**TOWN OF SALEM, NEW HAMPSHIRE
PRESSURE REDUCING VALVE STATIONS
CONTRACT S2, DWGTF-34**

ADDENDUM NO. 2

③ WALL SECTION 1
3/4" = 1'-0"

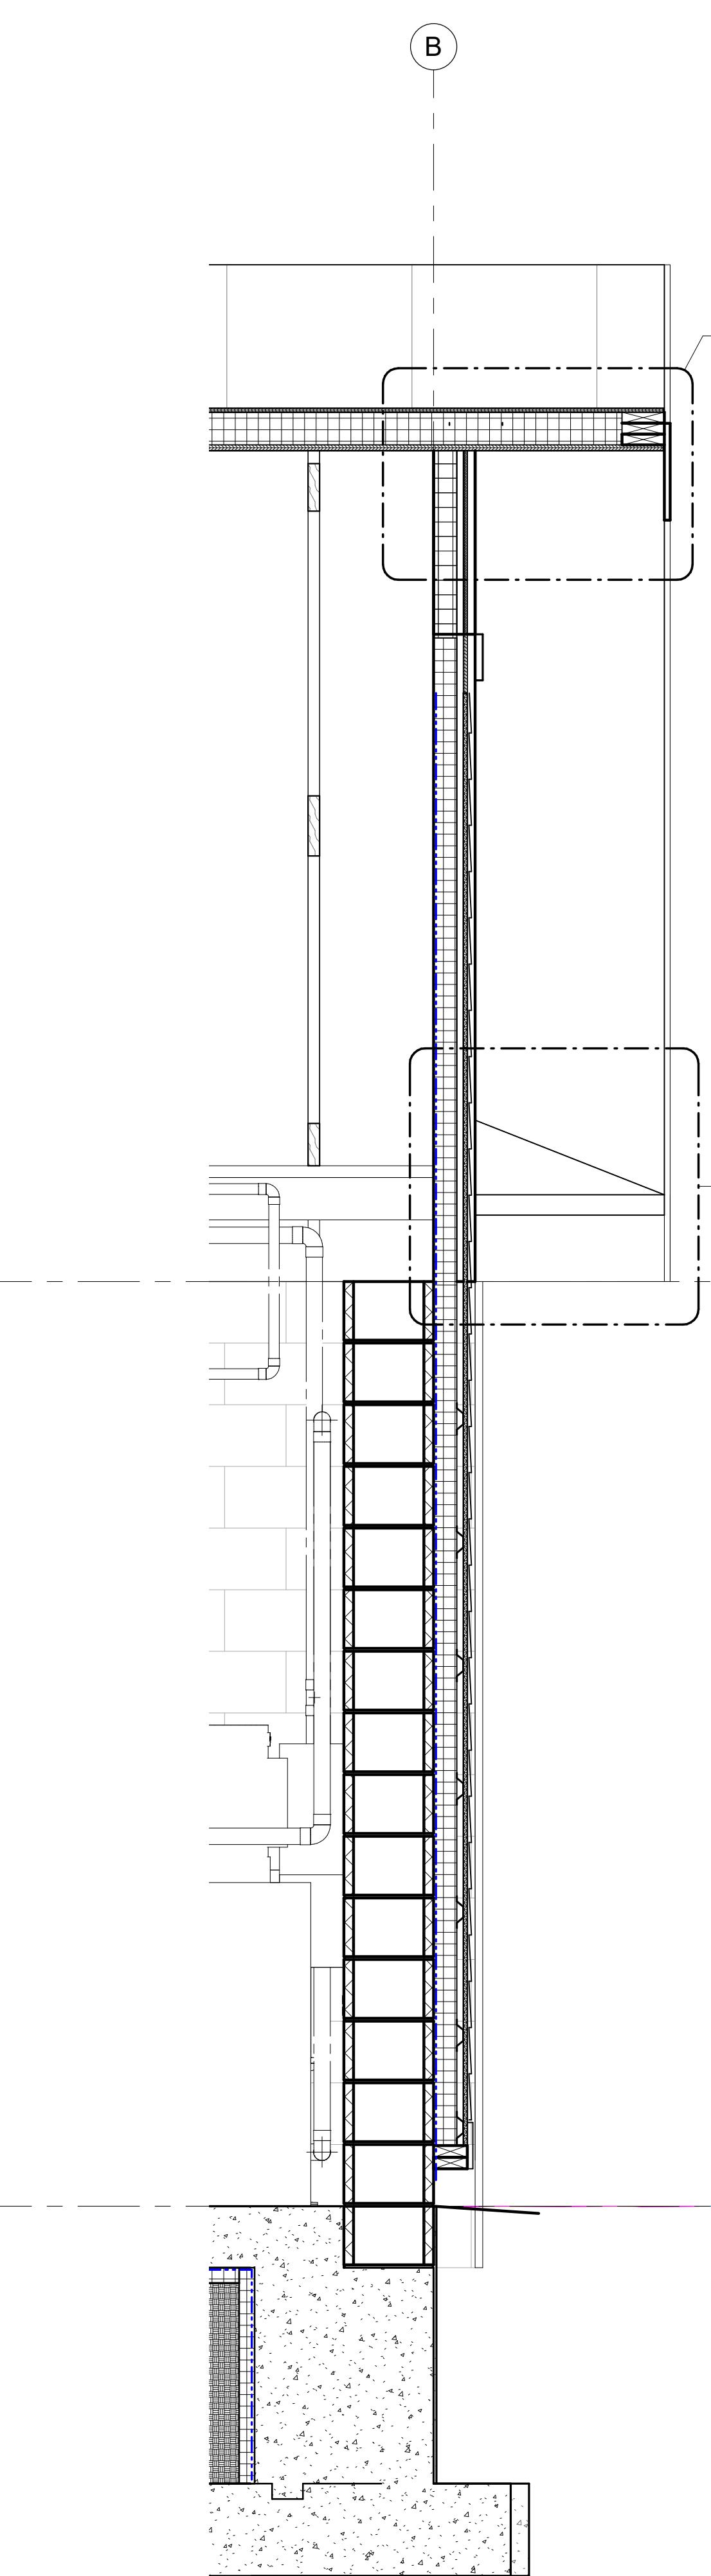
- 1. On Drawing A104, delete Detail 3 in it's entirety and replace with the attached Drawing A104 - Detail 3.

Question: Detail 3 on Sheet A104 Calls for a 3” metal steel deck but is not shown. Please show where the 3” steel deck is going and how it is fastened to the trusses.

Question: Detail 3 on Sheet A104 calls for 5 ½" vented insulated but there is no detail how it is to be fastened to the trusses. Please provide detail on fastening requirements.

Question: Detail 3 on Sheet A104 shows a 7/8" furring strip on the 3" rigid insulation but how it is fastened to the masonry block is not detailed.

Answer: There is no metal deck being used on this project. See Updated Drawings (A104 and A204) for Corrected Notes

Answer: Please review Spec Section 06 10 00 for fastening requirements.

Answer: There is no detail for this item. Please see Spec Section 07 21 00 for Attaching rigid insulation.
